7/21/21	<span style="color:red">6</span> Added Removal of Existing Delineators
7/14/21	<span style="color:red">4</span> Added Clear & Grub Limits
DATE	REVISION
STATE OF HAWAII DEPARTMENT OF TRANSPORTATION HIGHWAYS DIVISION	
<b>DEMOLITION AND EROSION CONTROL</b>	
<b>INTERSTATE ROUTE H-1 RESURFACING</b>	
Miller Pedestrian Overpass to Kapiolani Interchange	
Federal-Aid Project No. NH-HI-1(279)	
Scale: 1" = 40'	
Date: August 2021	
SHEET No. EC4 OF 23 SHEETS

<b>DEMOLITION AND EROSION CONTROL</b>	
INTERSTATE ROUTE H-1 RESURFACING	
Miller Pedestrian Overpass to Kapiolani Interchange	
Federal-Aid Project No. NH-HI-1(279)	
Scale: 1" = 40'	
Date: August 2021	
SIGNATURE	04/30/22
EXPIRATION DATE OF THE LICENSE	
SHEET No. EC7 OF 23 SHEETS

DEMOLITION AND EROSION CONTROL	
<u>INTERSTATE ROUTE H-1 RESURFACING</u>	
<u>Miller Pedestrian Overpass to Kapiolani Interchange</u>	
Federal-Aid Project No. NH-HI-1(279)	Date: August 2021
Scale: 1" = 40'	
SHEET No. EC8 OF 23 SHEETS

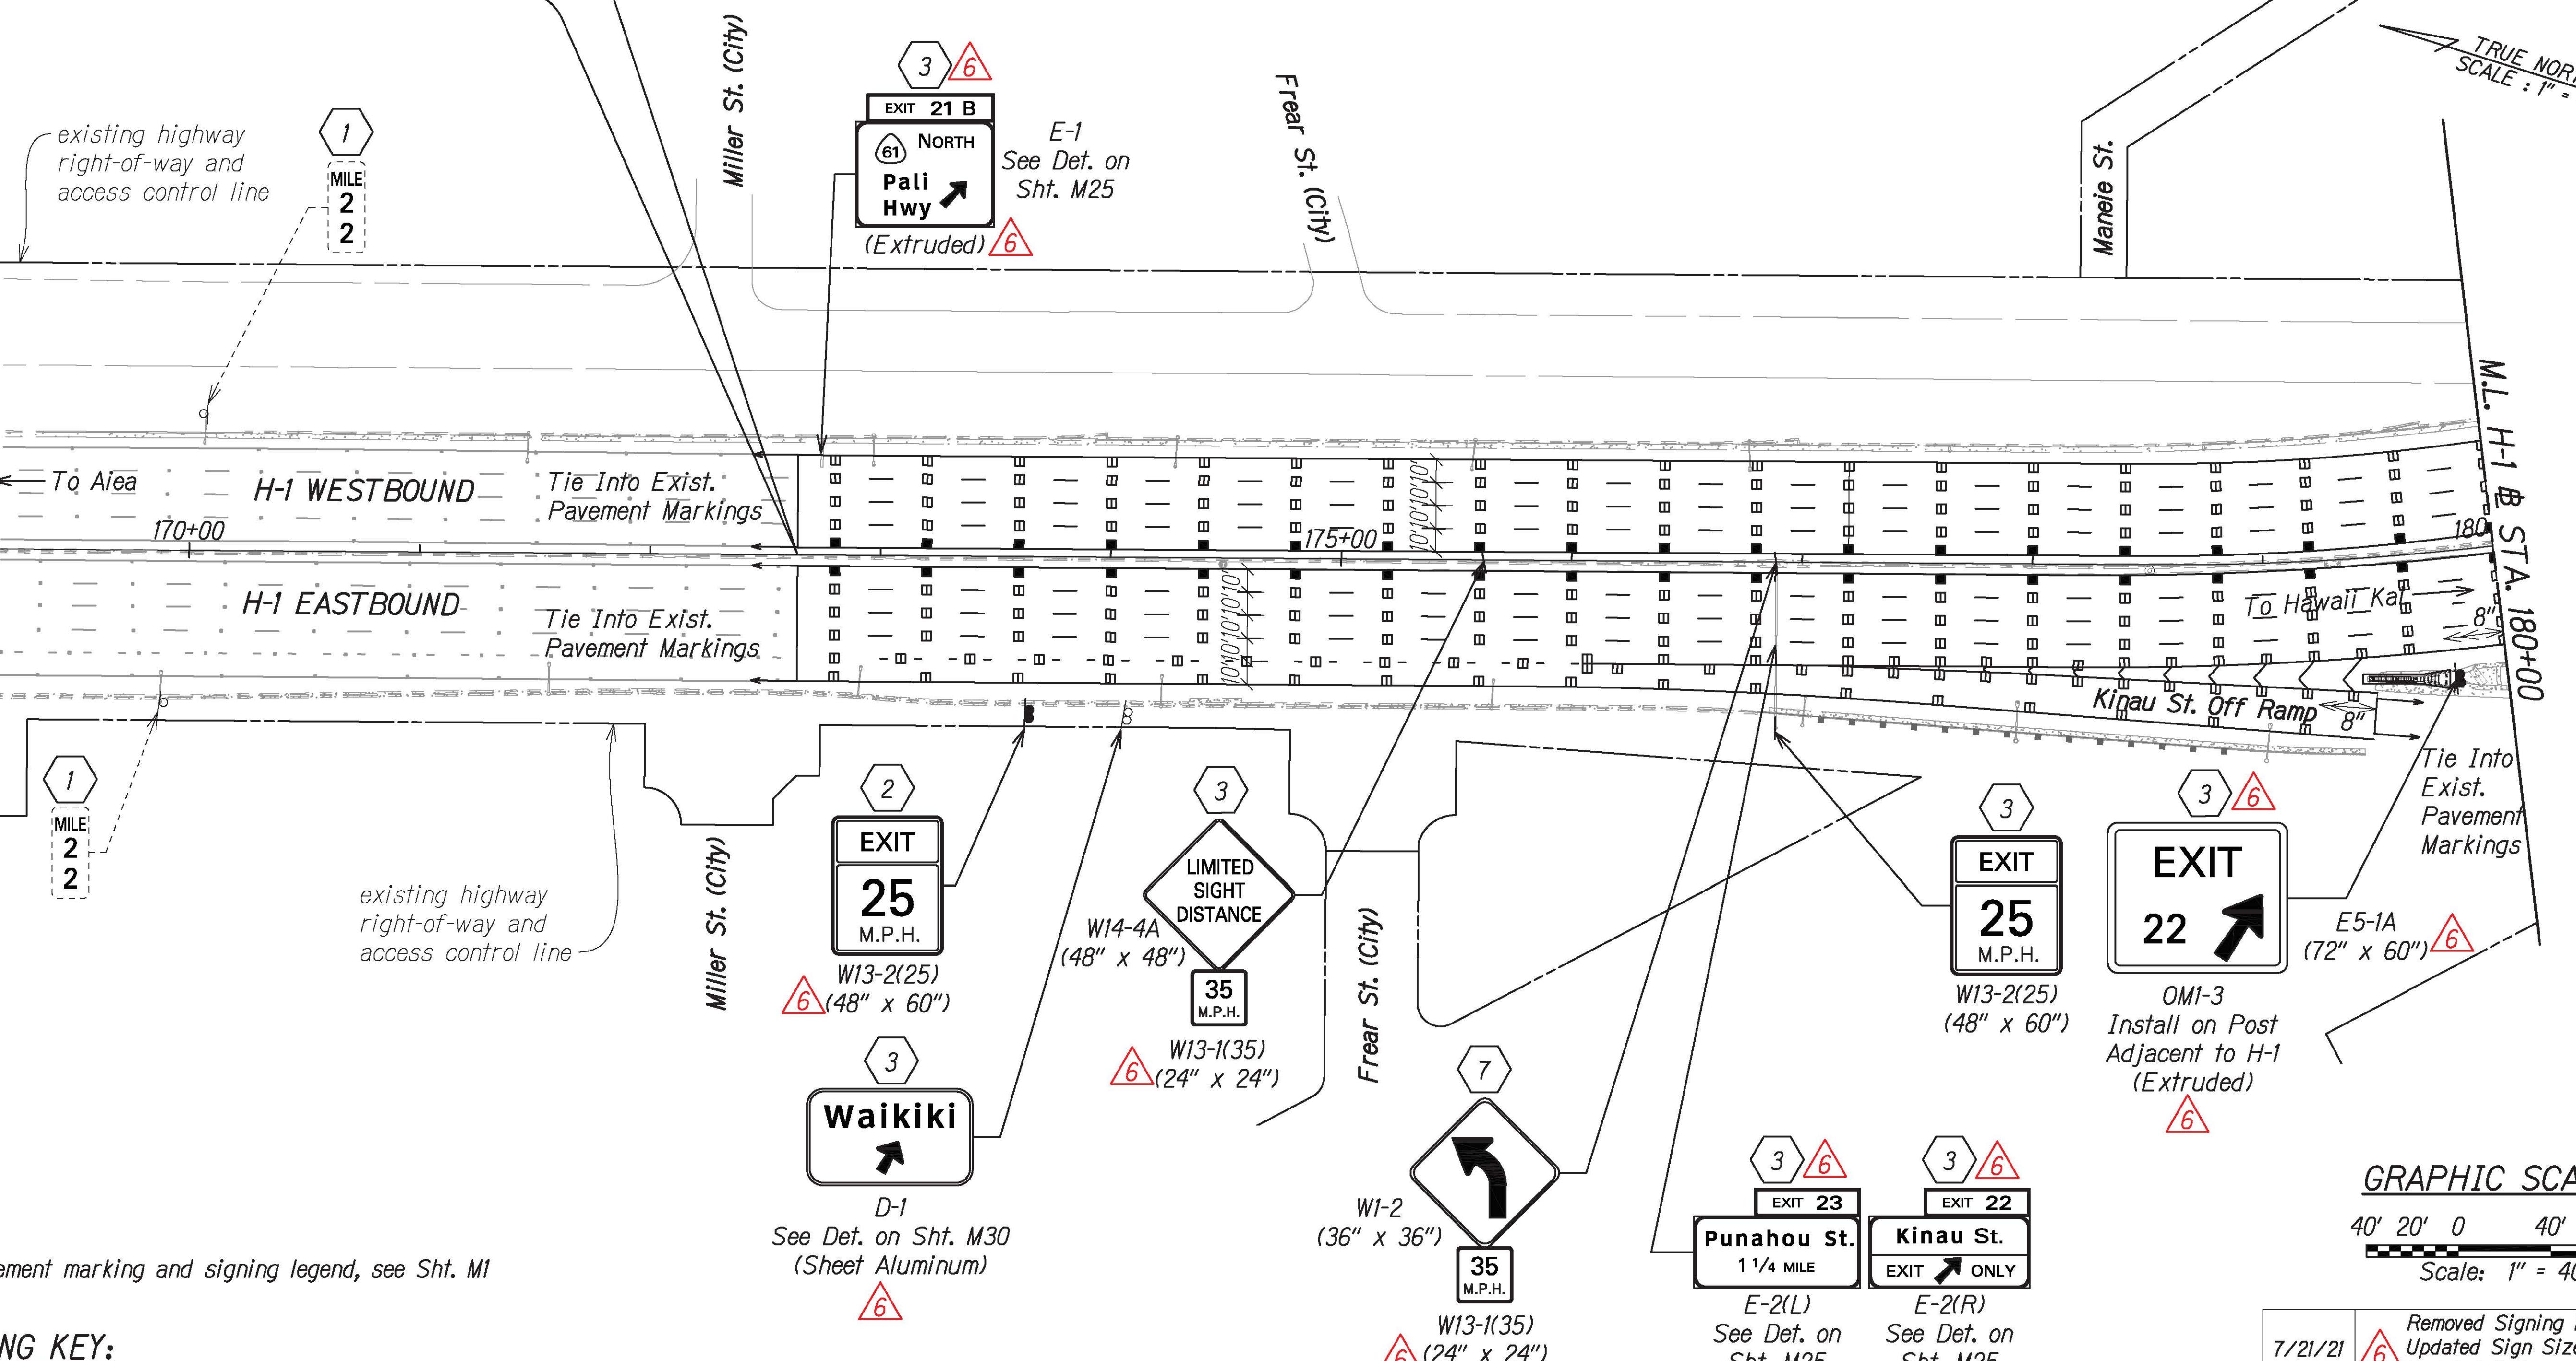
7/21/21	Removed Signing Key No. 10, Updated Sign Size and Updated Reference Note ⑥
DATE	REVISION
STATE OF HAWAII DEPARTMENT OF TRANSPORTATION HIGHWAYS DIVISION	
<b>PAVEMENT MARKING &amp; SIGNING PLAN</b>	
INTERSTATE ROUTE H-1 RESURFACING Miller Pedestrian Overpass to Kapiolani Interchange	
Federal-Aid Project No. NH-HI-1(279)	
Scale: 1" = 40'	
Date: August 2021	
SHEET NO. M2 OF 34 SHEETS

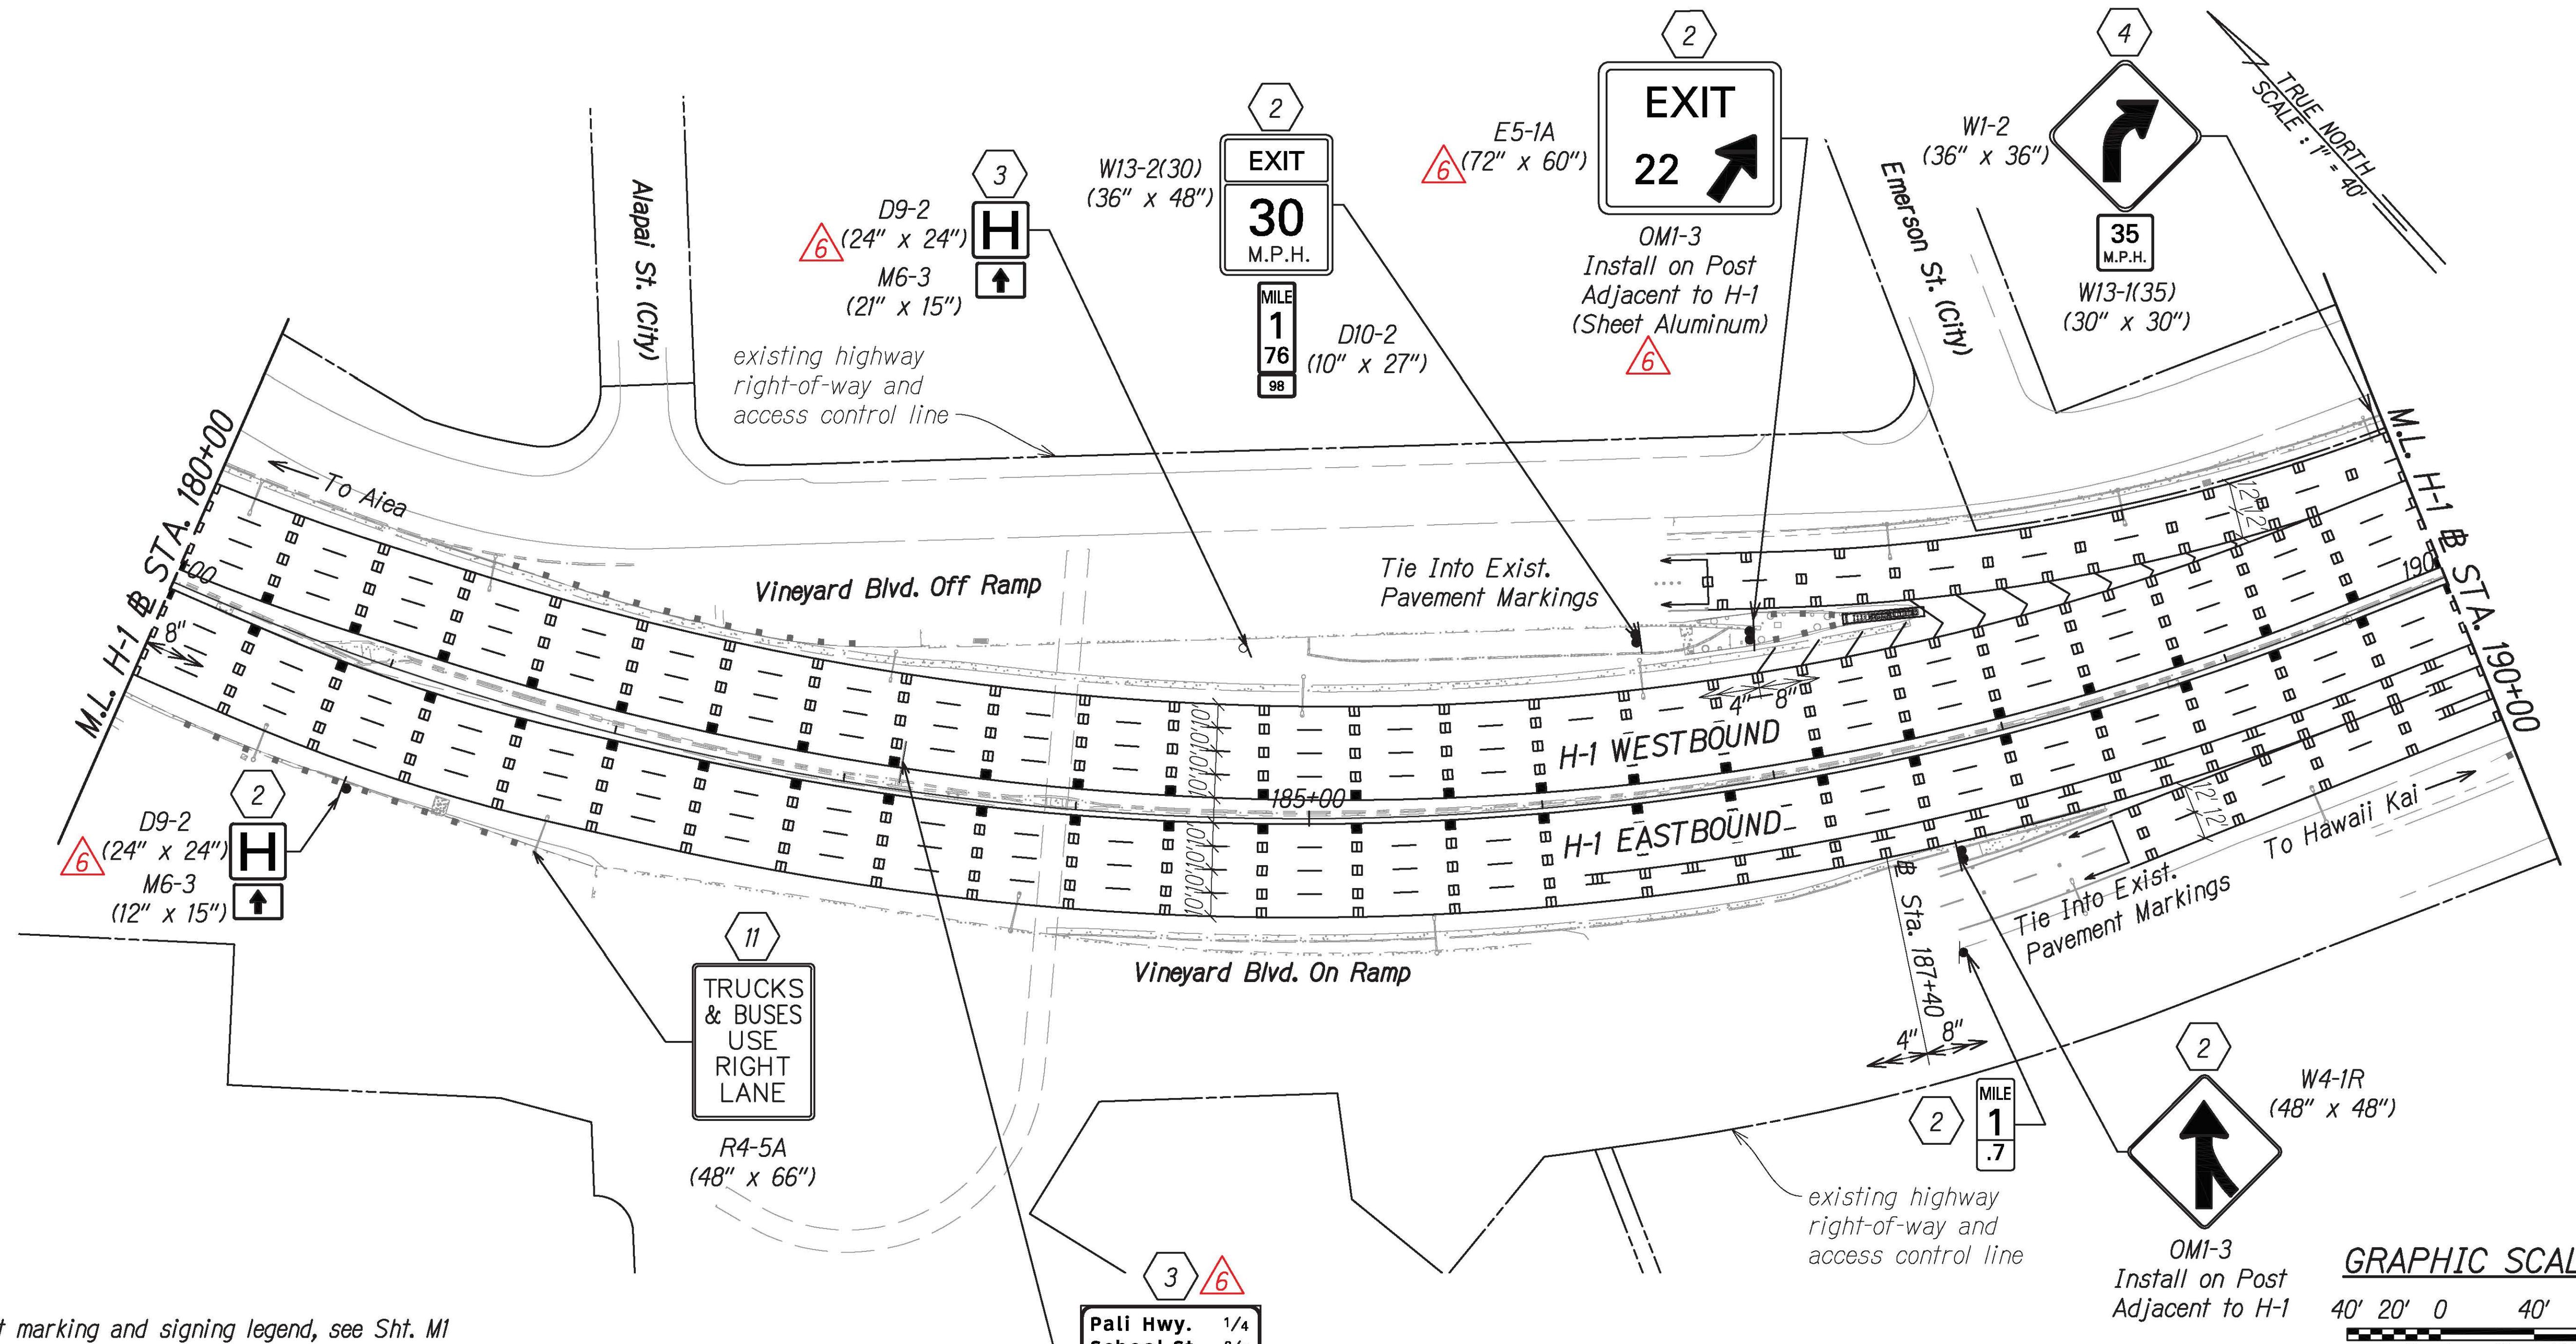
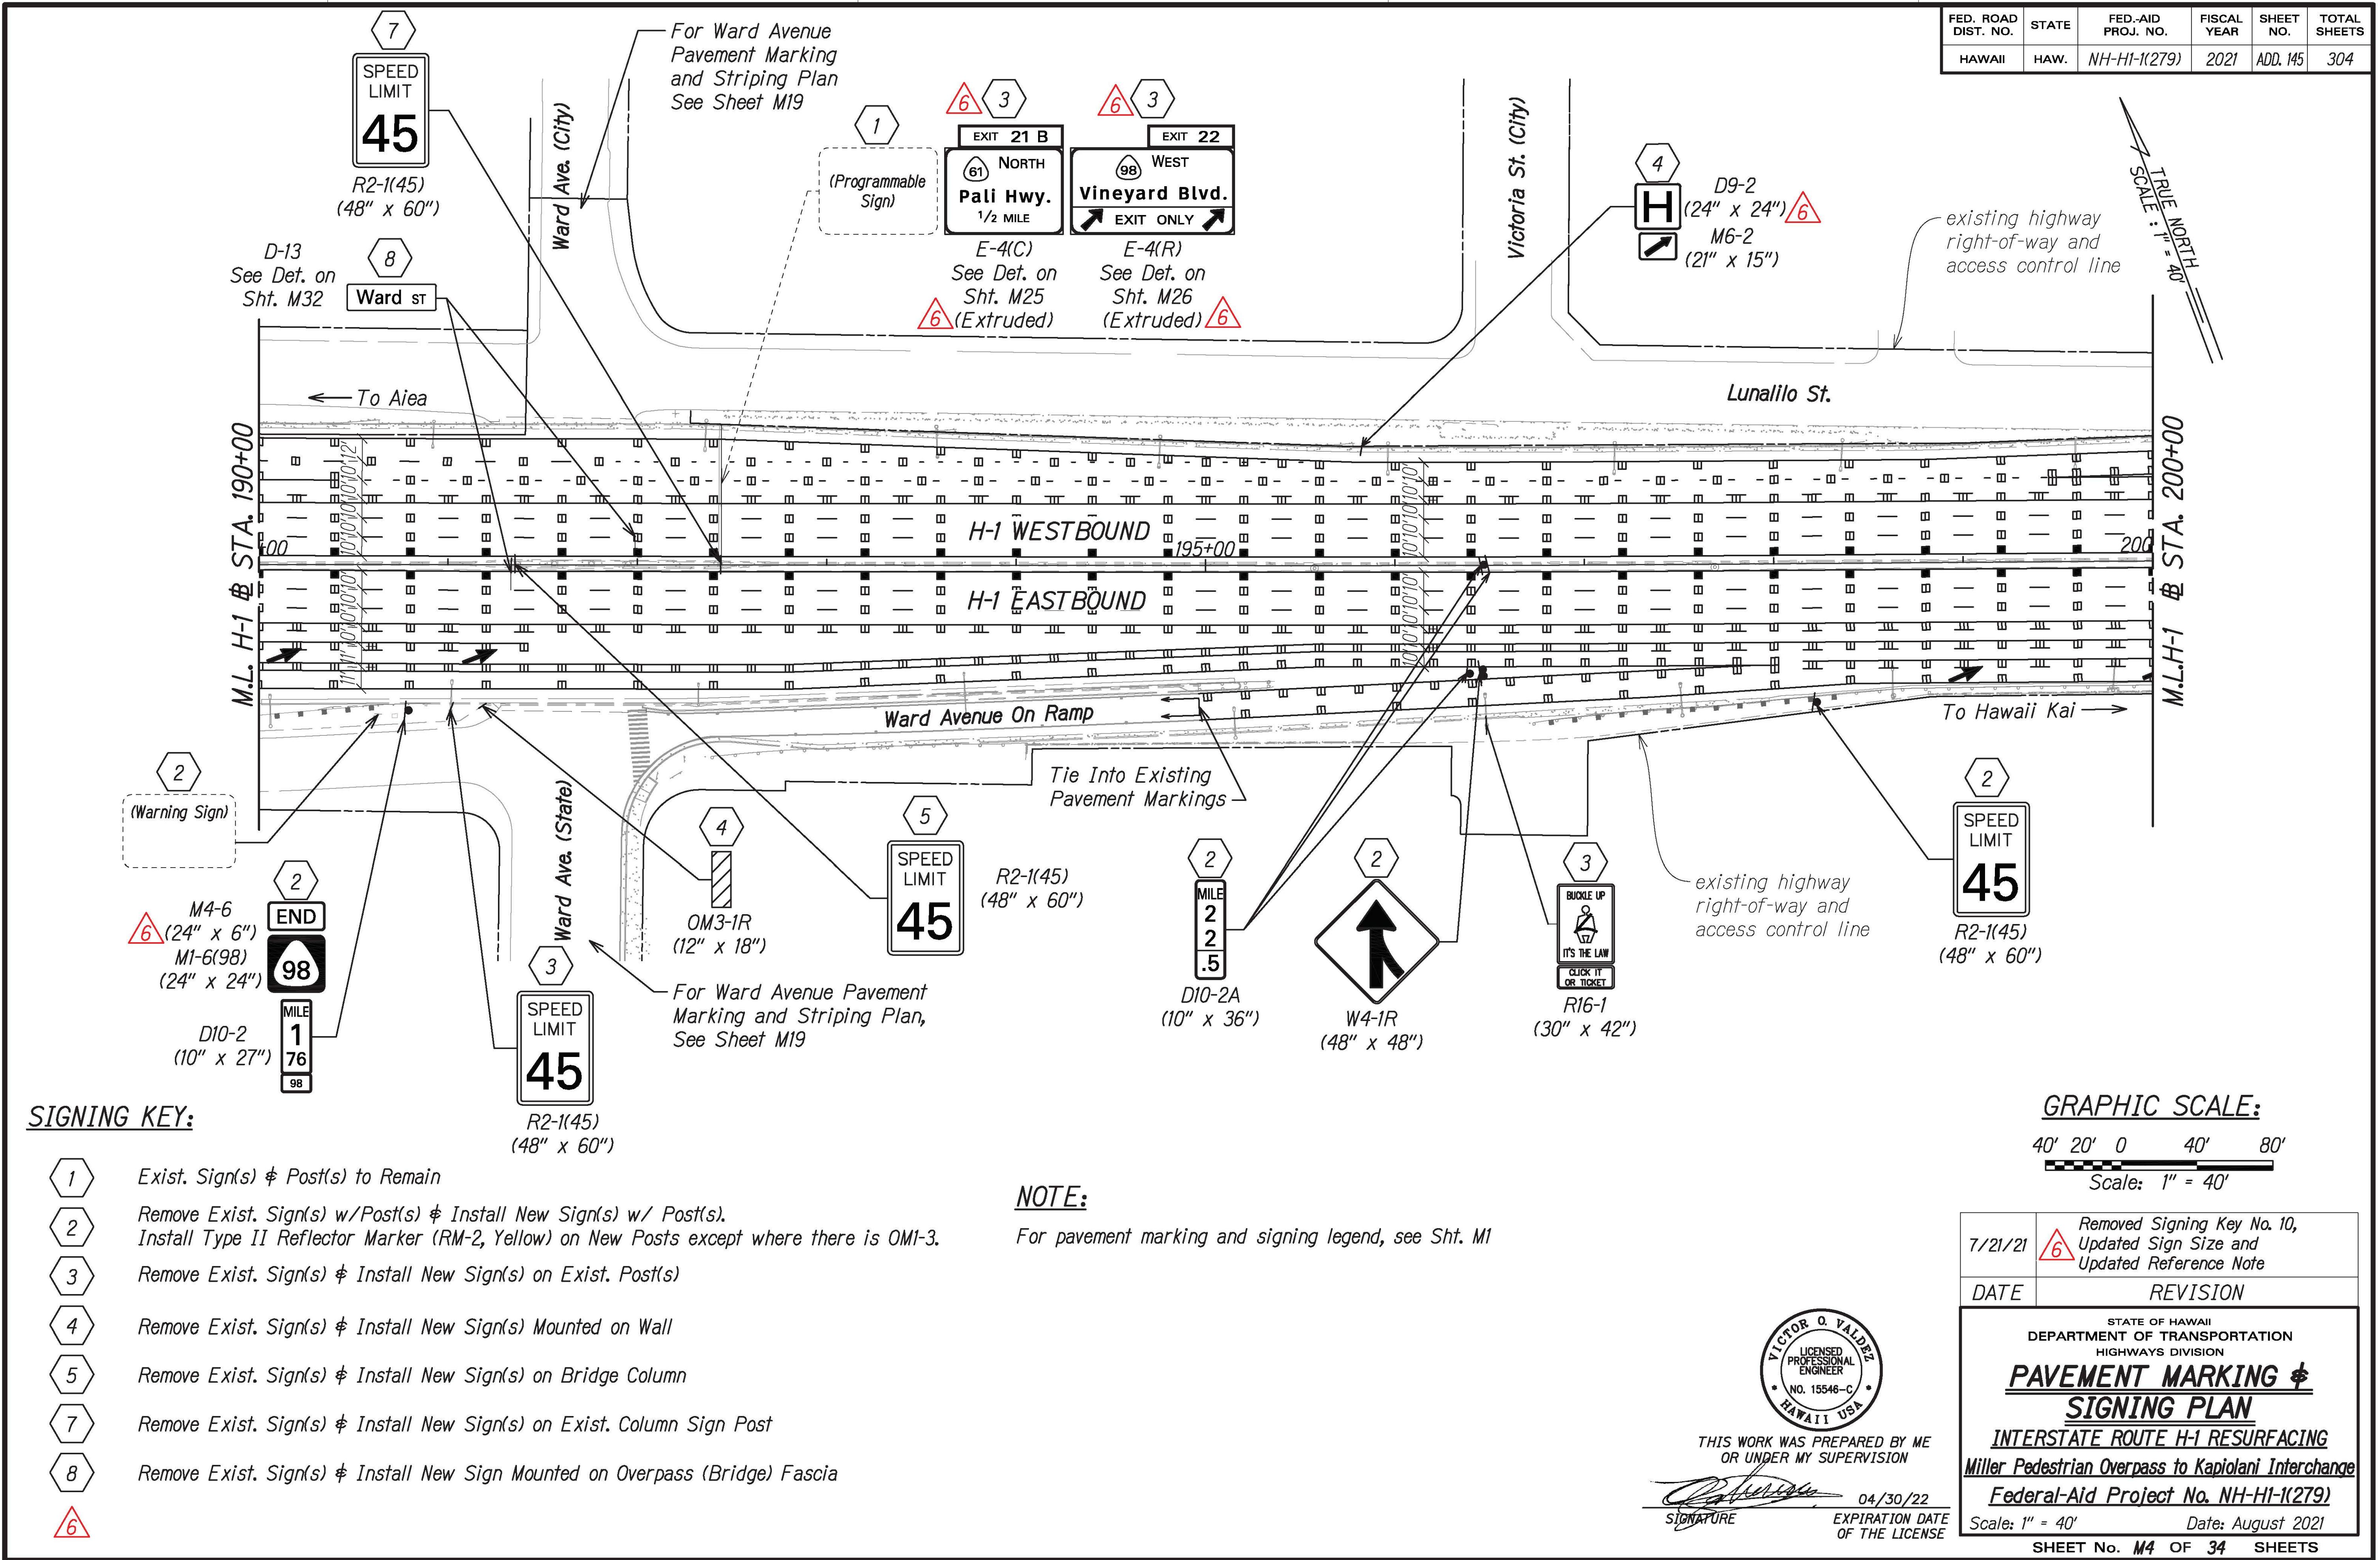
7/21/21	Removed Signing Key No. 10, Updated Sign Size and Updated Reference Note <b>(6)</b>
DATE	REVISION
STATE OF HAWAII DEPARTMENT OF TRANSPORTATION HIGHWAYS DIVISION	
<b>PAVEMENT MARKING &amp; SIGNING PLAN</b>	
INTERSTATE ROUTE H-1 RESURFACING	
Miller Pedestrian Overpass to Kapiolani Interchange	
Federal-Aid Project No. NH-HI-1(279)	
Scale: 1" = 40'	
Date: August 2021	
SHEET No. M3 OF 34 SHEETS
